Minutes of the Design Review Panel Meeting 24 – September 24, 2009

[Project 1: "Emerald Park" Condo, 4726-4750 Yonge Street](#)

[Project 2: Lansing United Church, 49 Bogert Avenue](#)

[Project 3: Evolution Condo, 5101 Dundas Street West](#)

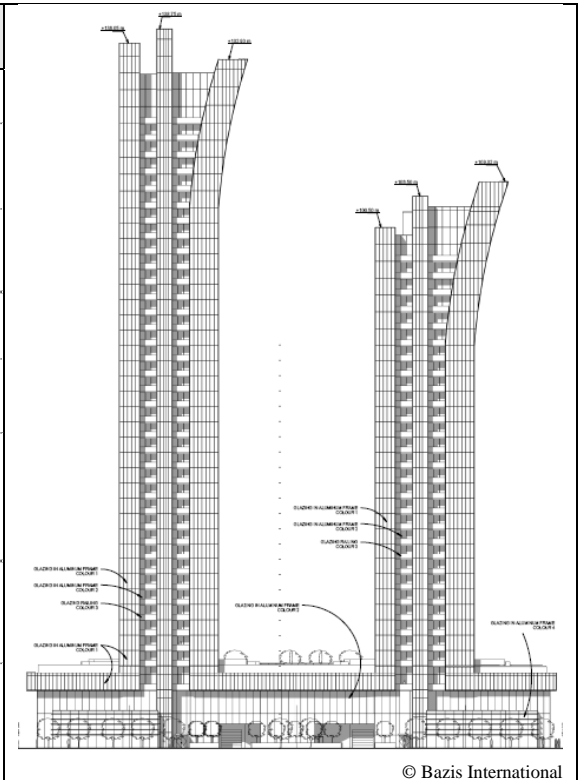
Sustainable Design

Continue to develop a comprehensive sustainable design strategy that is integrated throughout the project, including but not limited to:

- articulated passive means of solar control that addresses orientation of facades
- further development of tower skin to ensure optimum insulation properties
- develop commercial space floor plate depth and window strategy to increase natural light penetration

Site Plan Design

Further develop to address the following:

- Building edge and sidewalk design to more clearly respond to the usage and character differences of the four streets framing the site
- Along Bogert Avenue:
 - consider providing drop off area along street at residential lobbies
 - increase visual screening of vehicular access area
- Address circulation conflicts presently shown in design between bikes, taxis, cars and trucks:
 - including entering/exiting parking garage, bike storage and loading area

- consider condensing loading area to help resolve conflict (varying opinions amongst Panel members regarding condensing this area)

The Panel sees positive improvement in the design with the extension of the building closer to the property line. Further development is needed in the following areas:

- Pedestrian realm vs. retail edges of building:
 - articulate and give scale to retail uses, including entry conditions and weather protection
- Pedestrian realm vs. commercial edges of building
 - consider public/private transition relative to pedestrian circulation immediately adjacent to potential office uses

The Panel also appreciates the high quality of design clearly expressed in the fully rendering colour perspectives (the ones not included in the submission package), and has provided comments and support with the understanding that this quality will be maintained and achieved through to the completed project. Further to the above, development is needed in the following areas:

- General
 - develop high quality building skin to match intent clearly shown in fully rendered colour perspectives
- Retail/Commercial is given the same design along all street edges, although the streets are considerably different from each other:

- develop design to address this difference (for instance: Beecroft frontage should be handled differently than Yonge frontage)
- Street level base presently has a “corporate” aesthetic which does not reflect intended retail functions:

- develop a clear retail strategy and character including: different types/sizes of retail, entries, signage placement, canopies, etc...
 - articulate strategy for controlling the extent of opaque retail frontage, to ensure an animated clearly visible retail environment

- provide design strategy for spaces that more likely will be used as commercial/office
- Tower
 - balconies are currently captured within the tower facades:

- push out / express balconies to encourage views, create pattern in façades and become part of solar shading strategy
 - develop expressed passive solar shading to address sun path and provide aesthetic scale/articulation

- Landscape strategy and related pedestrian realm and public/private transition that addresses potential commercial, office and/or retail uses along Poyntz, Bogert and Beecroft

- Unlike Yonge and Poyntz, the design Bogert is primarily a residential street:
 - increase quantity and quality of landscape to address and enhance this use, while screening vehicular access/egress and articulating residential entries/lobbies

- The widening of Poyntz at Yonge does not create/support a high quality urban environment and safe, enjoyable public realm
- Assistance from the City is needed to coordinate with the TTC to create a better integration of this entry into the proposed design
- We recommend that Poyntz remain at a consistent width up to the corner of Yonge, using the road width shown at the corner of Poyntz at Beecroft.
